# Fairfield Village at Quincy Reservoir

## SITE PLAN AMENDMENT

Fairfield Village  
at Quincy Reservoir  
Site Plan

Add Following Notes with revision delta:

### 1 Secondary Entry Monumentation

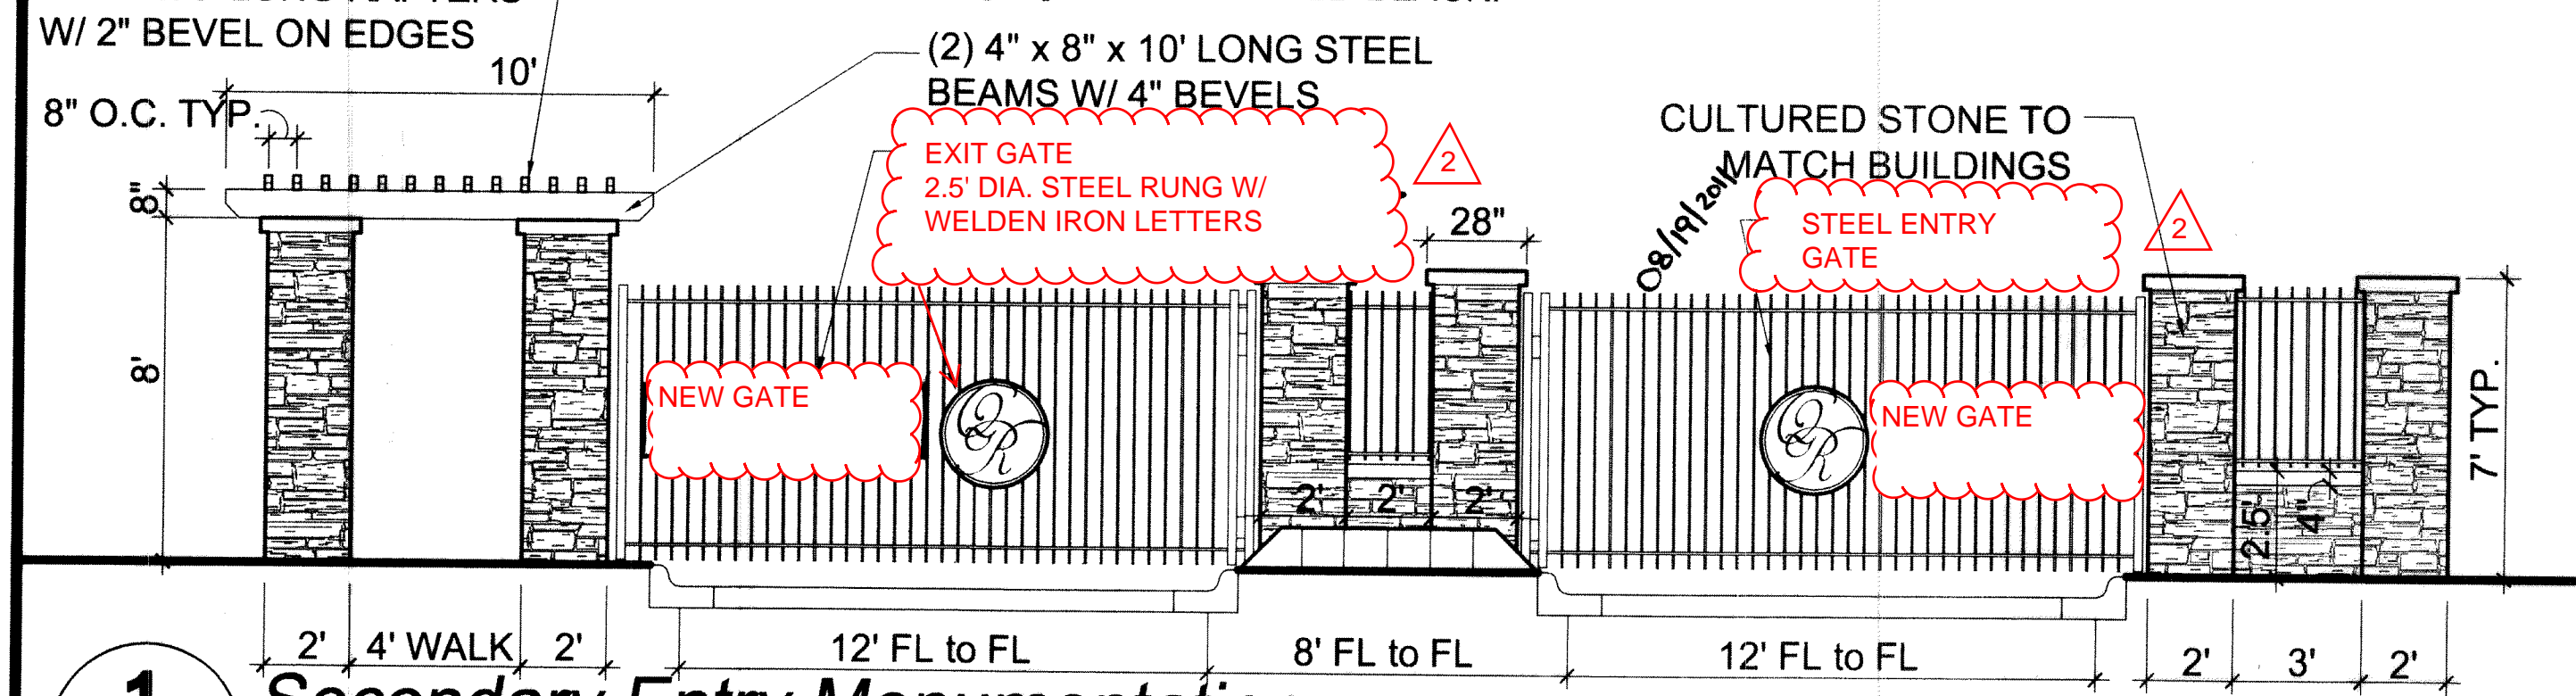
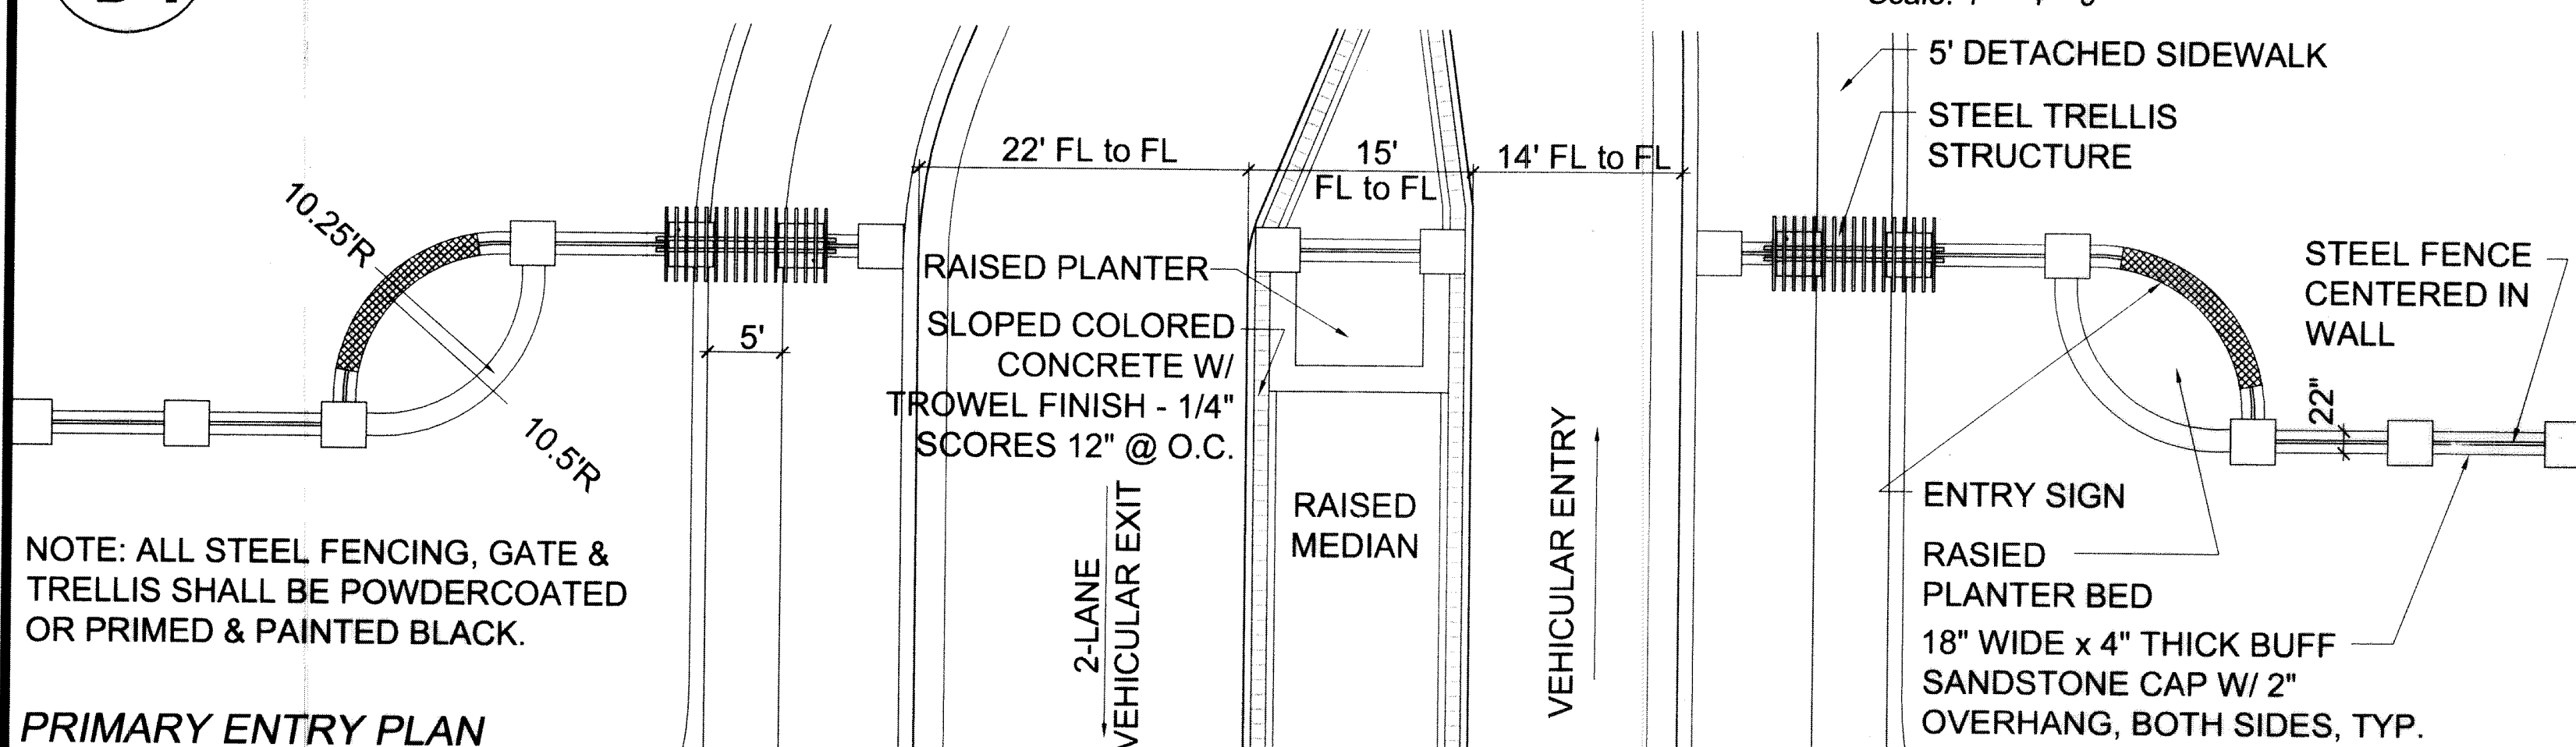
Add detail of FD ACCESS sign and arrangement of access, Knox box and FD access sign.

Change item A) to "Siren Operated System."
